### CERTIFICATE OF APPROPRIATENESS

TAX MAP N°: 73.1.3 PARCEL N°: 112  
 Street & Number of Proposed Work: 17 PROADWAY  
 Owner of record: PRICKLY PINE 90 PARKER STREET LLP  
 Mailing Address: 1 CONSTITUTION CENTER  
BOSTON, MA 02129  
 Contact Phone #: (214) 915-9010 E-mail: crumpf.e.tsi@usa.com

1. East Elevation (1) RECONSIDER PORCH - ATTIC LEVEL  
 2. South Elevation (2) ELIMINATE 2ND FLOOR PORCH - ATTIC MASS  
 3. West Elevation (3) RECONSIDER 2ND FLOOR WINDOWS - EVIDENCE OF OPEN SPAN HISTORICALLY  
 4. North Elevation (4) REPLACE WINDOWS ON SOUTH 1ST FLOOR TO TWO

17 BROADWAY- SIASCONSET  
 REV TO HDC2020-03-0845  
 ALTERATIONS TO EXISTING  
 5-15-20

PROPOSED SOUTH ELEVATION

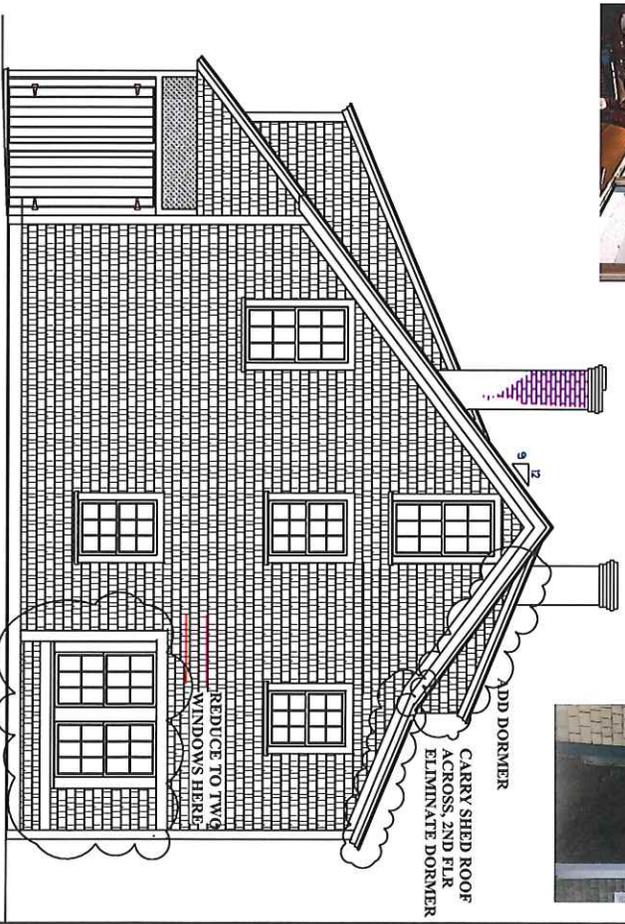
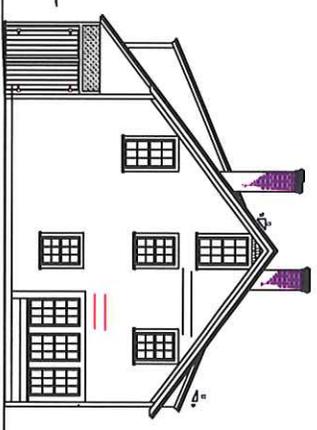
PROPOSED WINDOWS

PROPOSED SECOND FLOOR PLAN

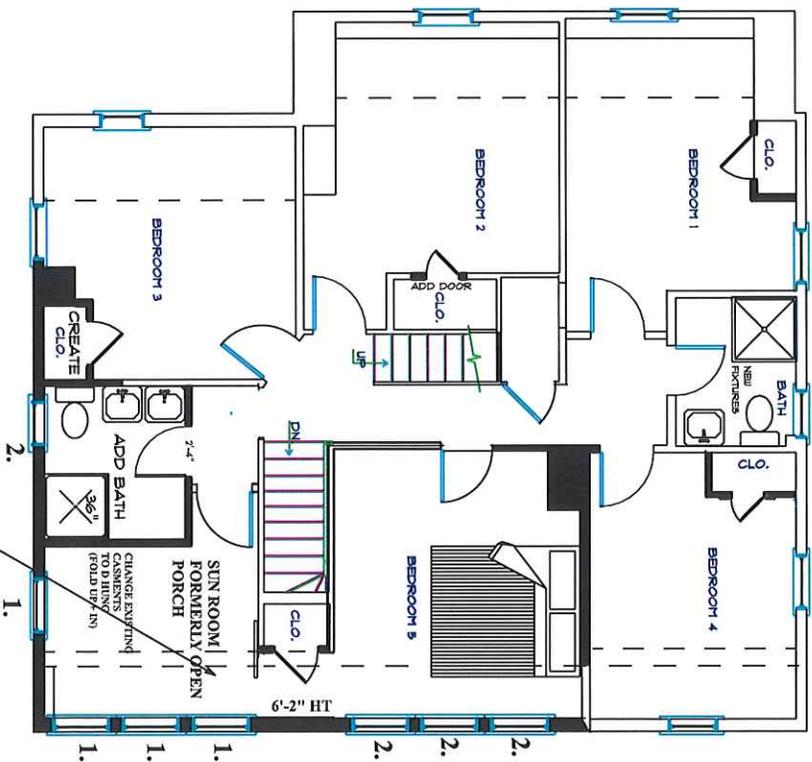
PROPOSED WINDOWS

- TRU DIVIDED LIGHT (WOOD) SINGLE GLAZE
1. D HING-TDL SINGLE GLASS (FOLD UP AND IN) - 31" X 44"
  2. D HUNG SIZE: 31" X 44"

PROPOSED THIRD FLOOR PLAN

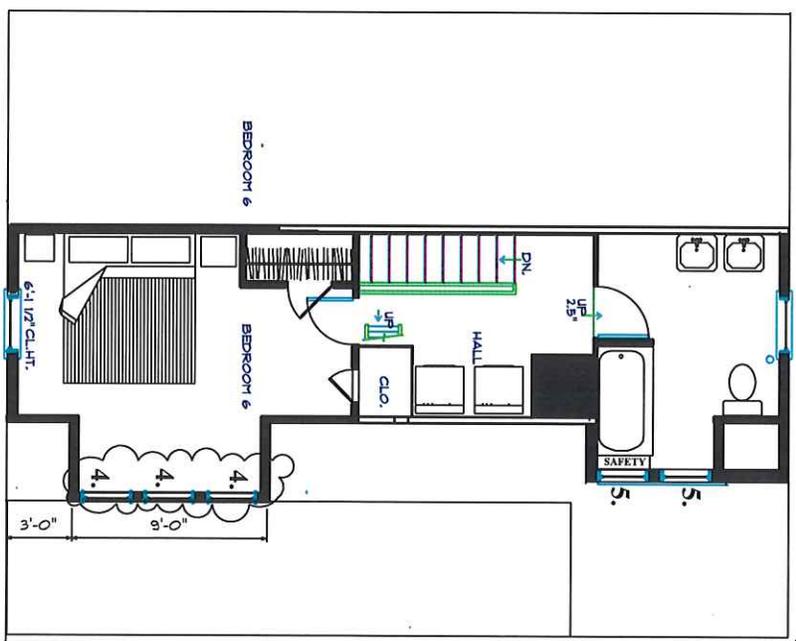
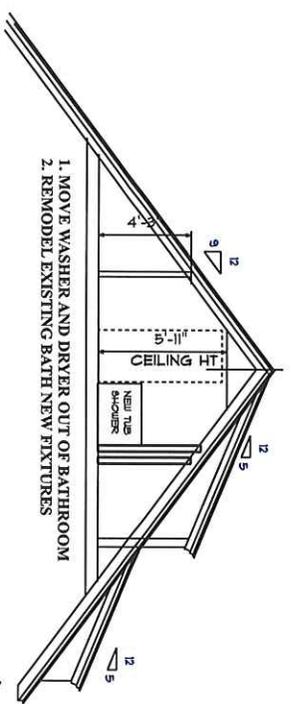
TRU DIVIDED LIGHT (WOOD) SINGLE GLAZE

4. D HUNG 28" X 24" 3/3

5. FIXED 28" X 12" 3 LIGHT
